**GARVEY COMMONS/ SHERBURNE HALL**  
ADDITIONS & REMODELING  
ST. CLOUD STATE UNIVERSITY  
ST. CLOUD MINNESOTA

REVISED	PROJECT NO. 86015
	ISSUE DATE 12-15-66
	DRAWN BY FEW
	CHECKED HV
	APPROVED ARCHITECT FW
	SCALE AS SHOWN

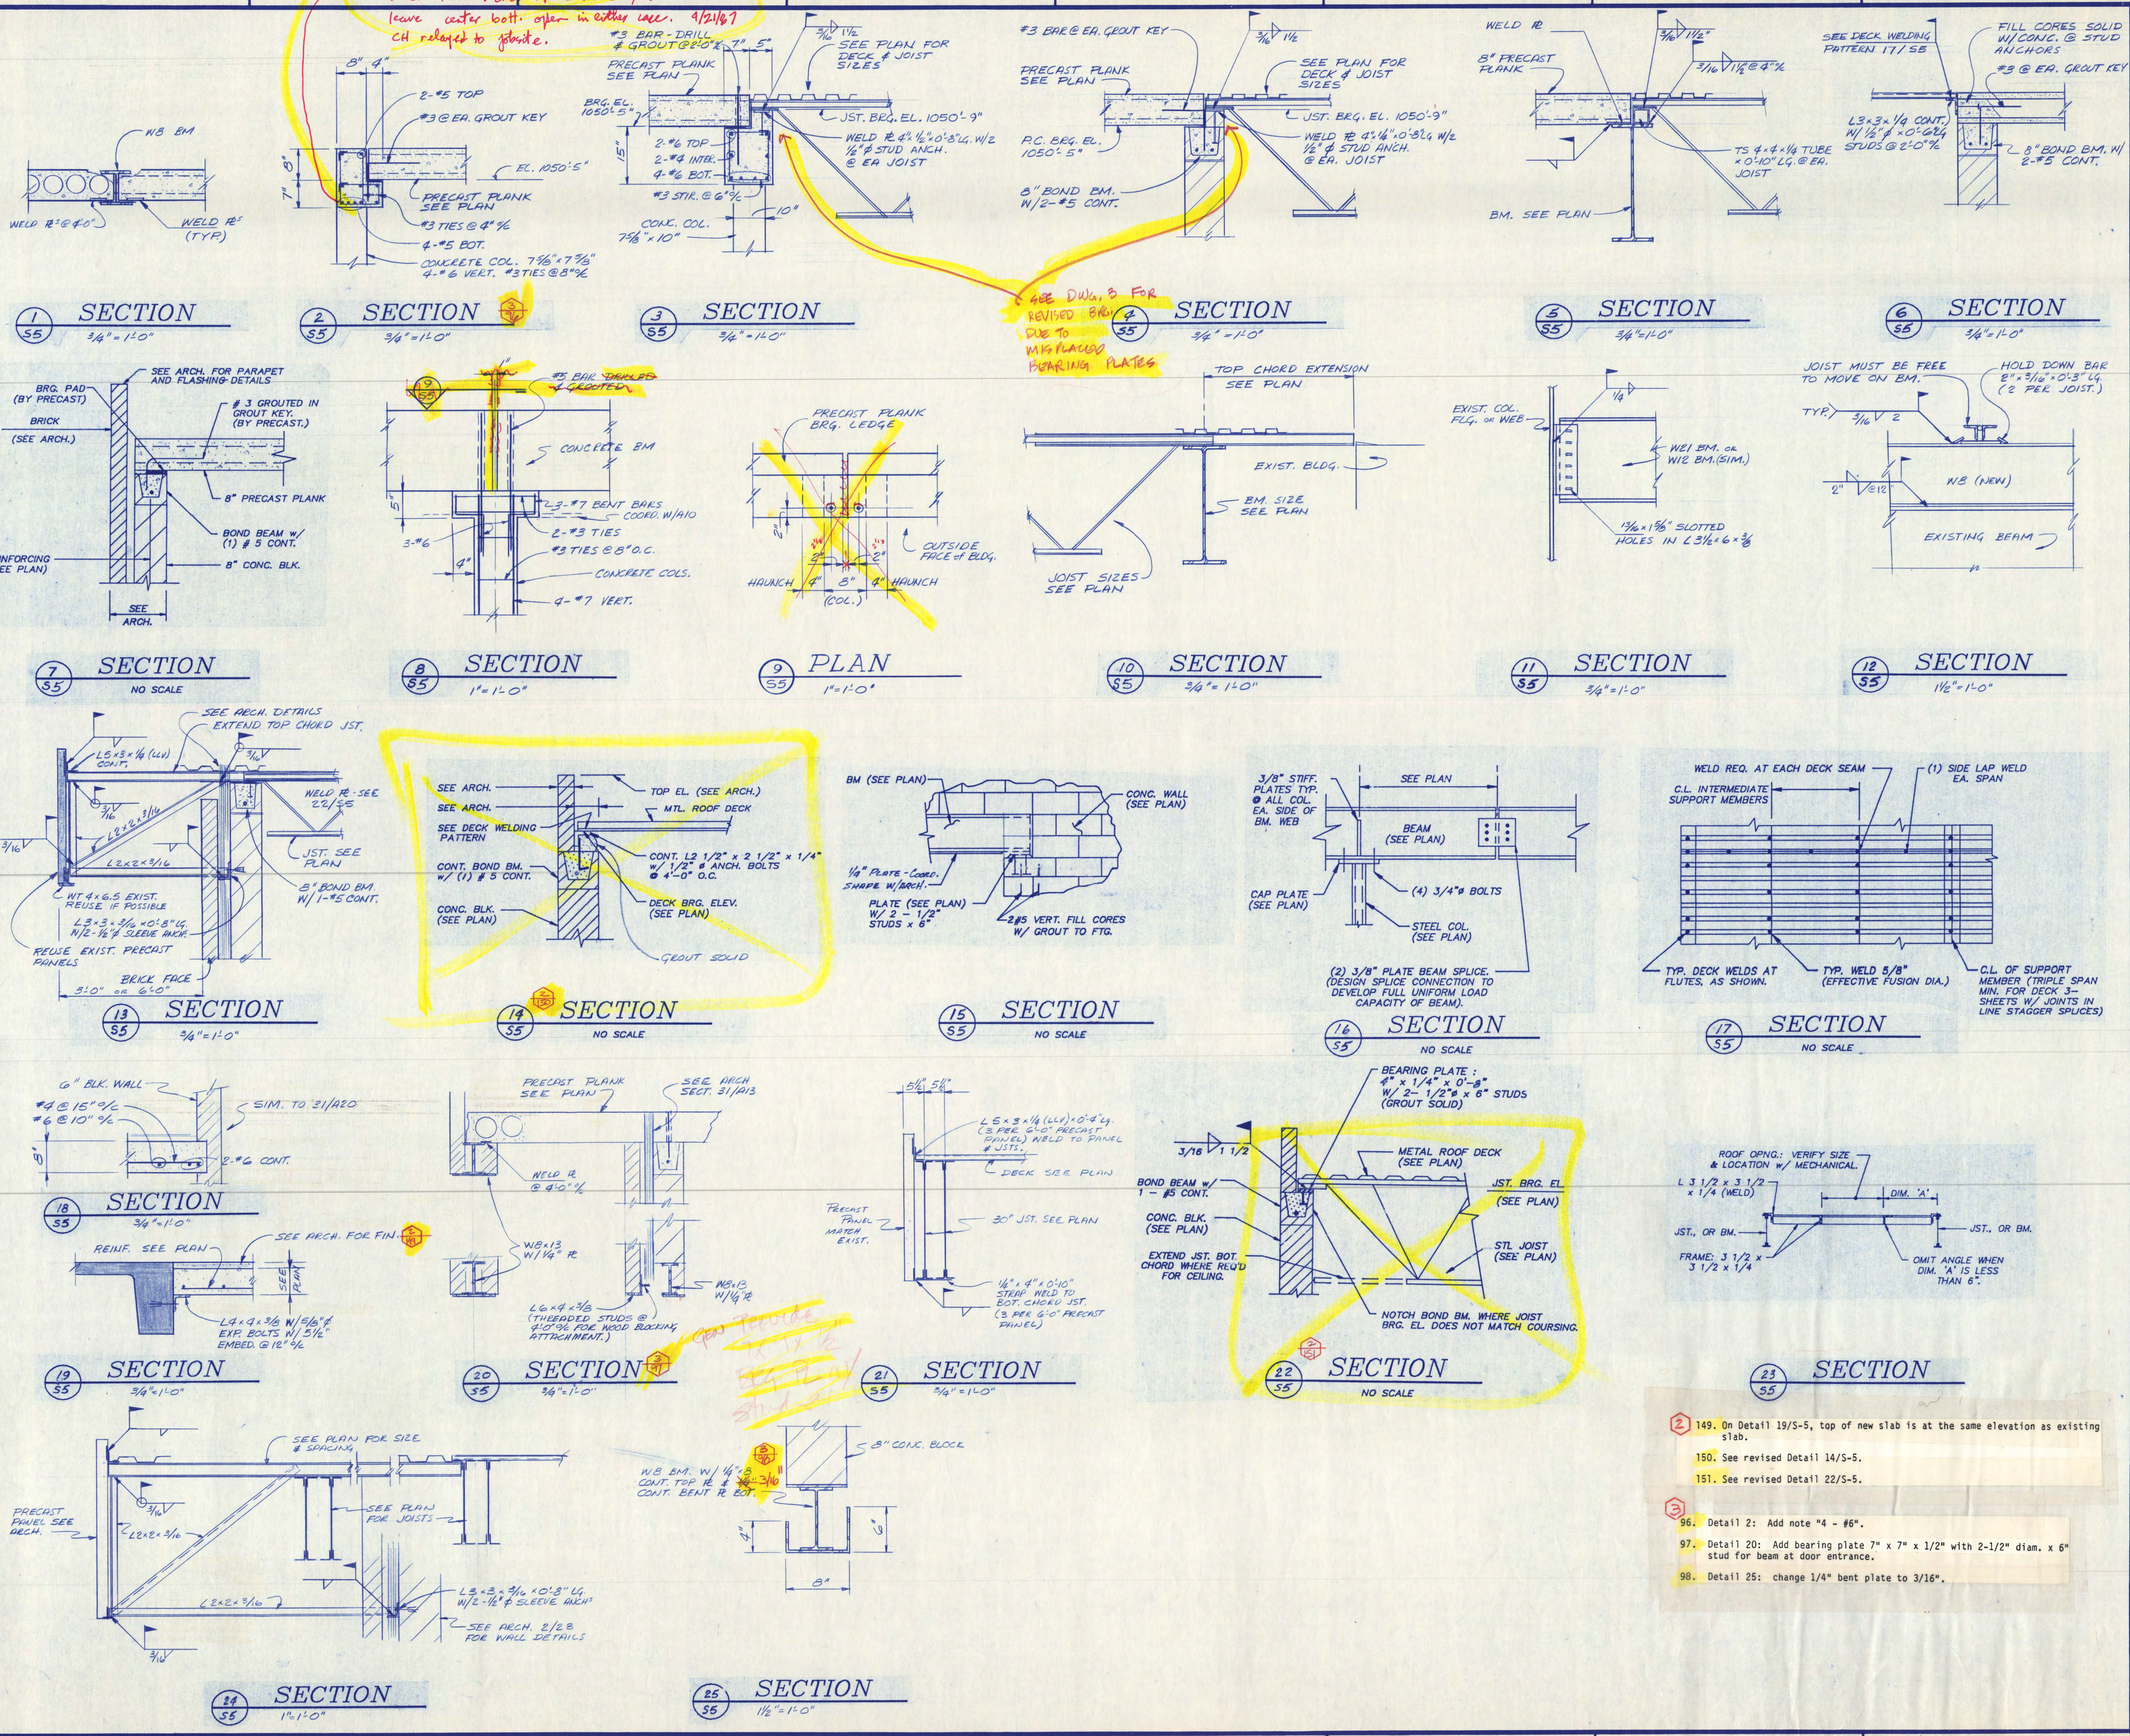
Keep said ok. to bundle 2-#5 @ ea. bot. corner or place 1-#5 @ ea. bot. corner then 1" clear space above of 2#5 above leave center bot. open in either case. 4/21/67 CH related to joint.

SEE DWG. 3 FOR REVISED BRG. #2 DUE TO MISPLACED BEARING PLATES

- 149. On Detail 19/S-5, top of new slab is at the same elevation as existing slab.
- 150. See revised Detail 14/S-5.
- 151. See revised Detail 22/S-5.
- 96. Detail 2: Add note "4 - #6".
- 97. Detail 20: Add bearing plate 7" x 7" x 1/2" with 2-1/2" diam. x 5" stud for beam at door entrance.
- 98. Detail 25: change 1/4" bent plate to 3/16".

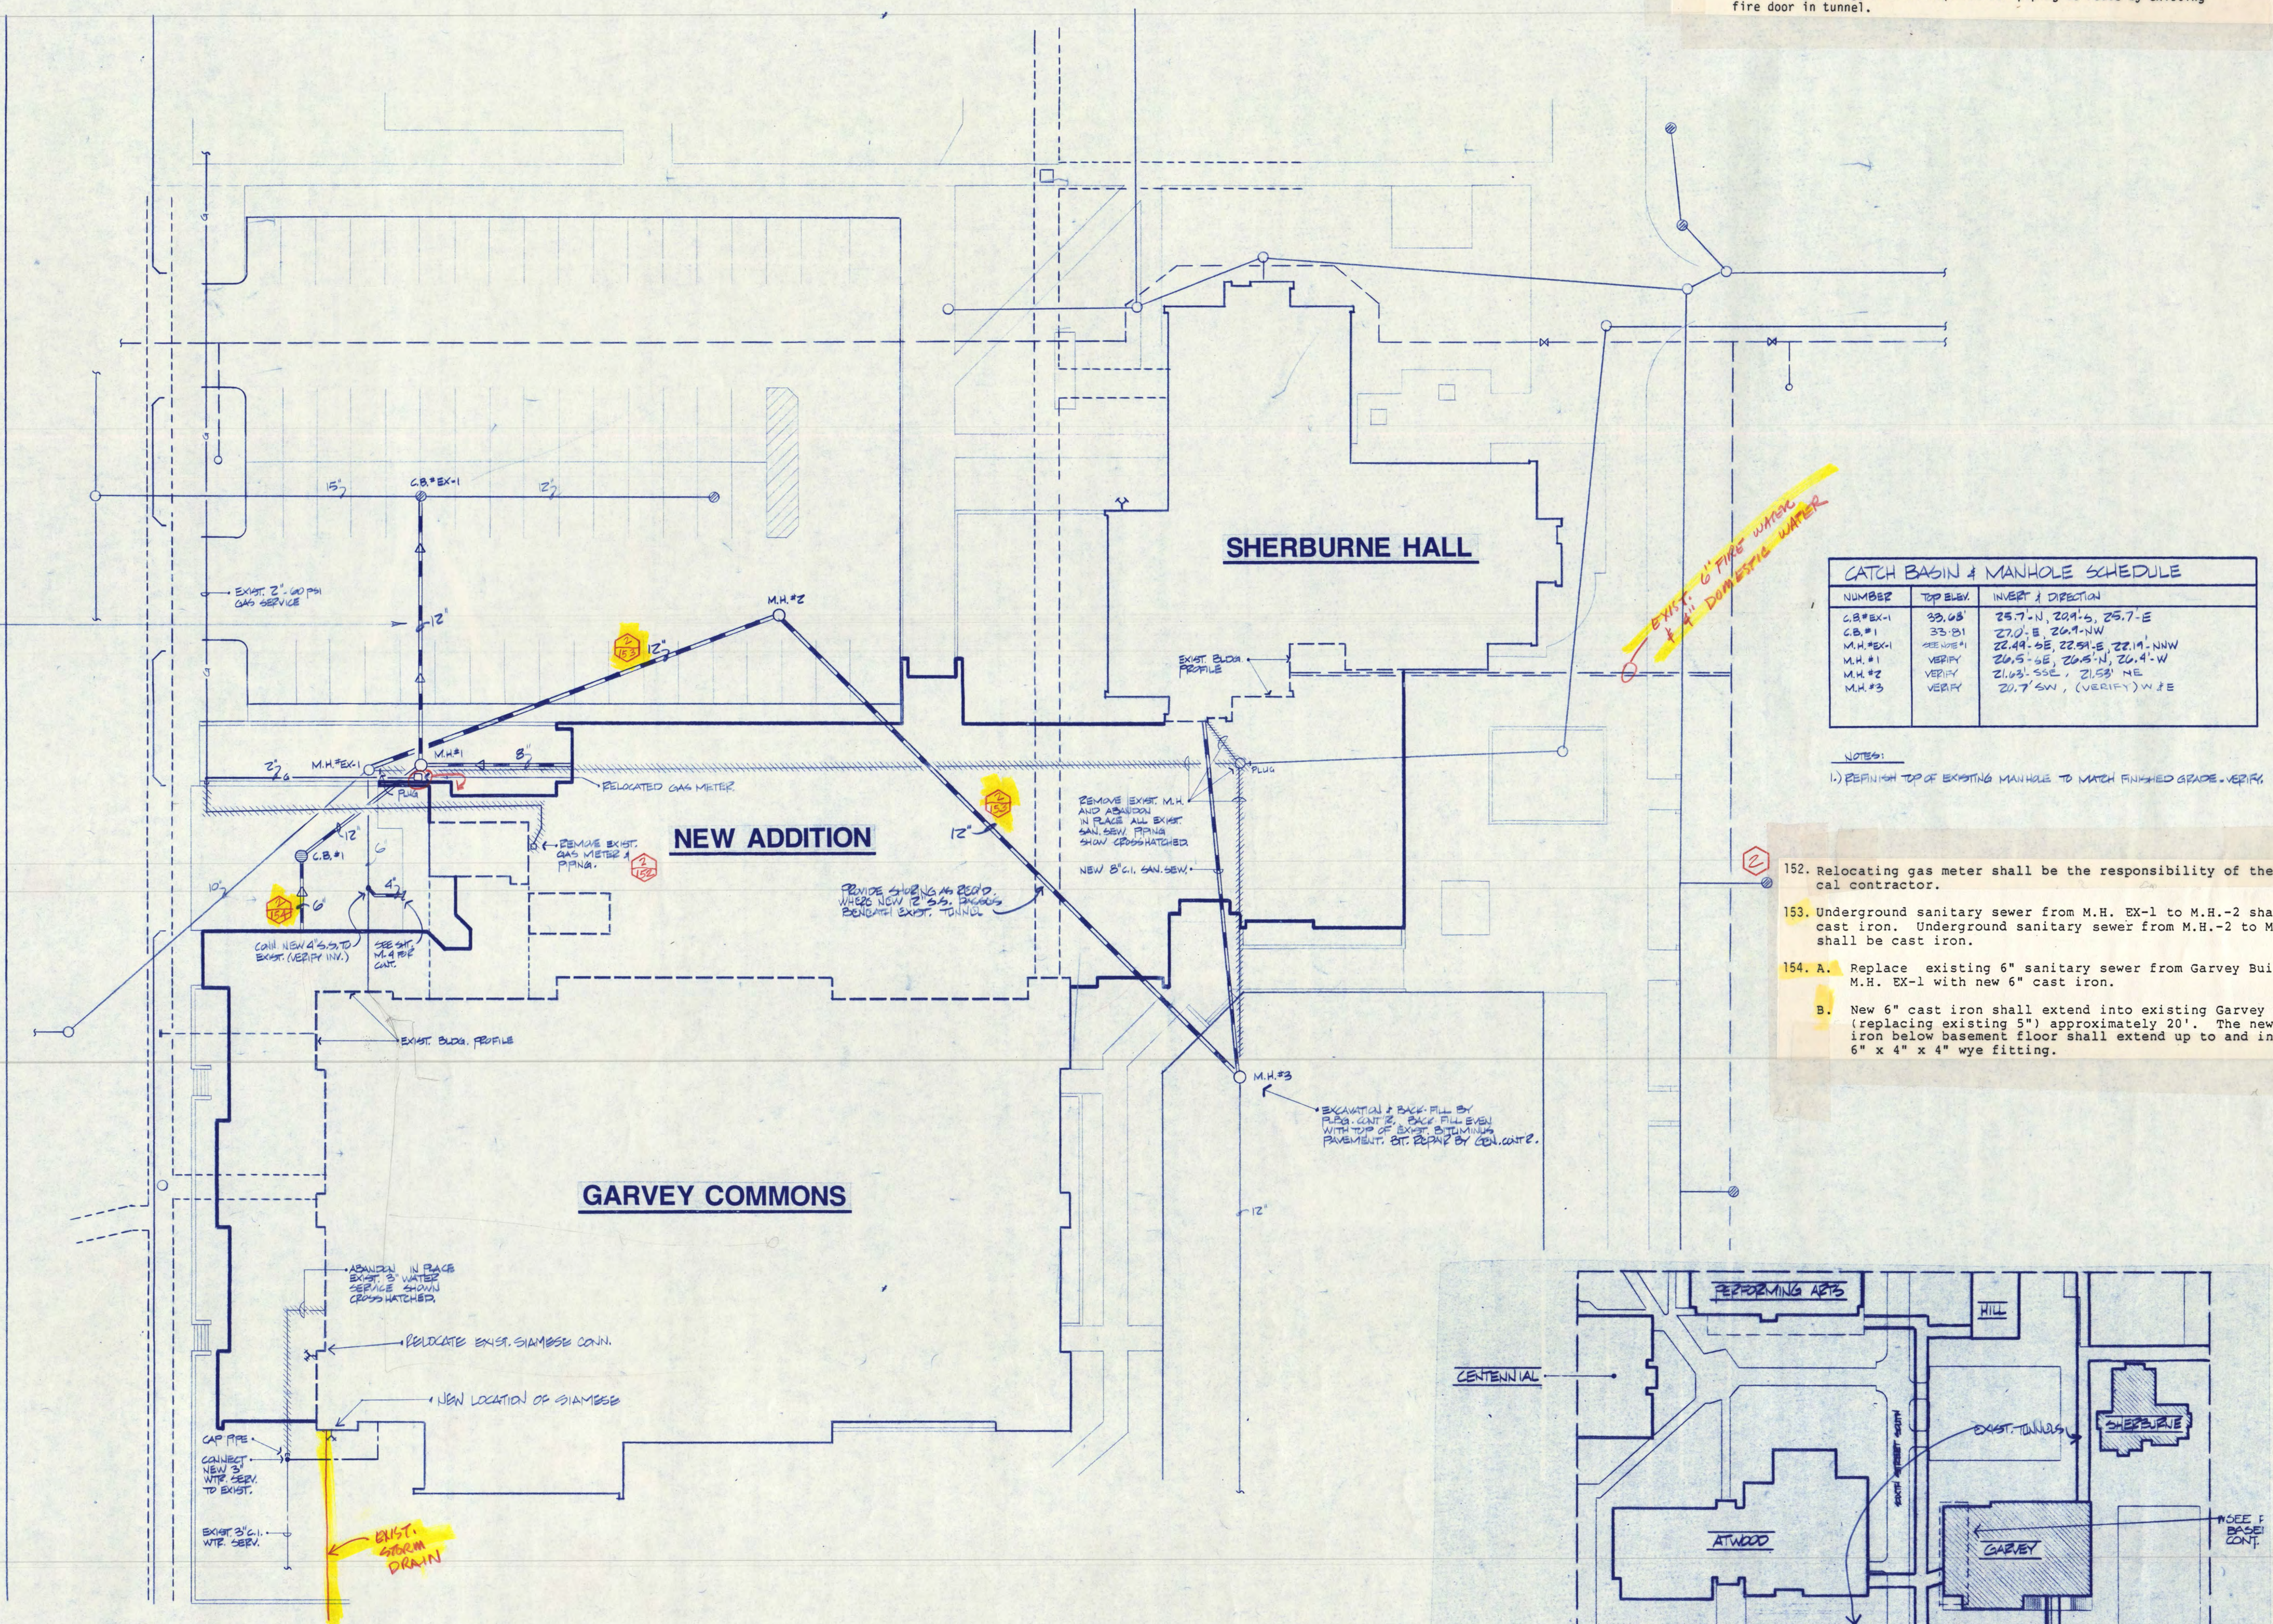
- 99. Chilled Water Piping in Tunnel. Support from existing pipe racks (similar to existing piping) where possible. Support remaining pipe per specification. Victaulic fittings are approved for piping in tunnel only.

- 100. Expansion compensators on chilled water piping in tunnel. Yarway Model 6236 installed in each pipe at 3 locations (6 total). One pair at chilled water piping between connection to existing chilled water and first tunnel intersection. One pair on chilled water piping between first tunnel intersection and turn to Garvey building. One pair on chilled water piping after turn to Garvey building.

- 101. Provide pipe anchors between all compensators and at each turn. Provide anchoring as recommended by compensator manufacturer.
- 102. Contractor shall include \$1,500 allowance to provide offsets, relocation of existing piping, etc. as required for piping to route by existing fire door in tunnel.
